**MODIFICATION REQUEST:**

***Vincentia District Centre – Corner Naval  
College Road and The Wool Road  
MP 06\_0025 MOD 4***

Modifications to the building footprint, finished floor level, roofline, internal mall widths, materials and finishes, loading dock and car parking.

Director-General's  
Environmental Assessment Report  
Section 75W of the  
*Environmental Planning and Assessment Act 1979*

**Figure 3: Approved Roof Structure**

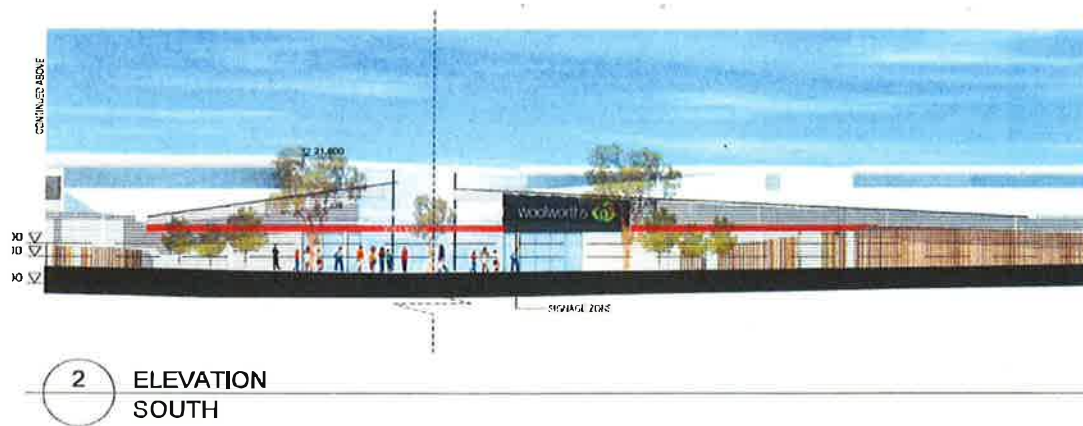
Following the enclosure of the arcades (Modification 3), structural analysis of the roof, and efficiency of roof plant condenser deck location, the proposal seeks to modify the configuration of the main arcade roof. The Department considers that the main issue regarding roof form

modifications relates to modifying the original design of the Centre that was the result of a Design Excellence Competition.

The original design included a sloping roof that was uncovered in the central walkway between the buildings. Modification 3 enclosed the walkways which created a modulated roof structure. This proposal seeks to create a flatter roof and reduce the height by 500mm (See Figure 3 and 4 below).

The Department considers that though the roof structure is different to the Rice Daubney design, the key design principles of the original design intent have been retained. This modification includes additional lighting in the form of skylights, glazed walls and clerestories, and the design now allows the maximum level of light into the building which supports one of the key design principles of blurring the distinction between indoors and outdoors.

The proposal seeks to lower the roof by 500mm. It is therefore unlikely that any adverse impacts with regard to view loss and visual impact will result.

**Figure 2: Street Cross Section of Existing and Proposed Setback to Moona Creek Road**

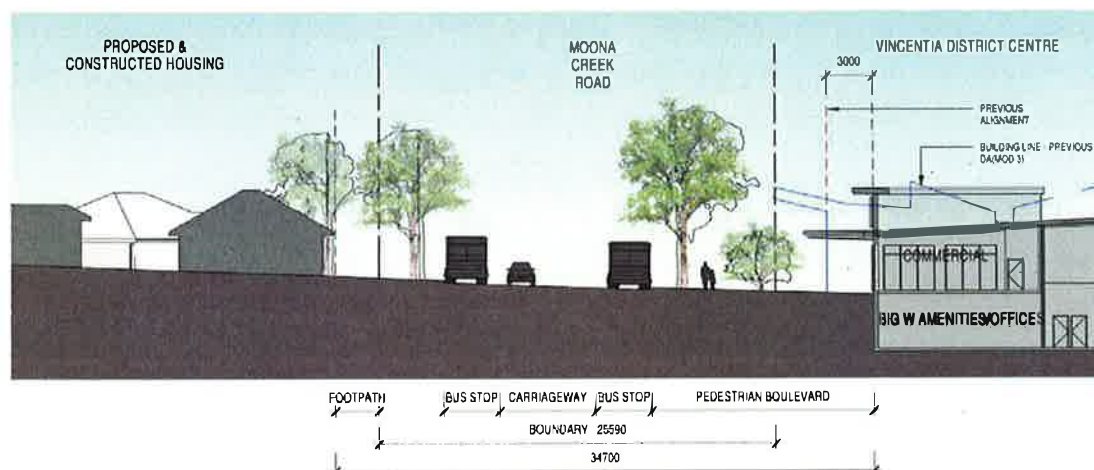
The proposal includes increasing the setback of the external walls of the specialty tenancies abutting the Wetlands on the north eastern façade by 5m. It is also proposed to increase the setback along Moona Creek Road by 3m.

As the above street cross section shows, the proposed additional 3m setback to Moona Creek Road appears minor in comparison to the overall width of the street. The proposed modification will not impact the original design intent of the concept of the 'gateway building' as the scale and façade treatments are being retained.
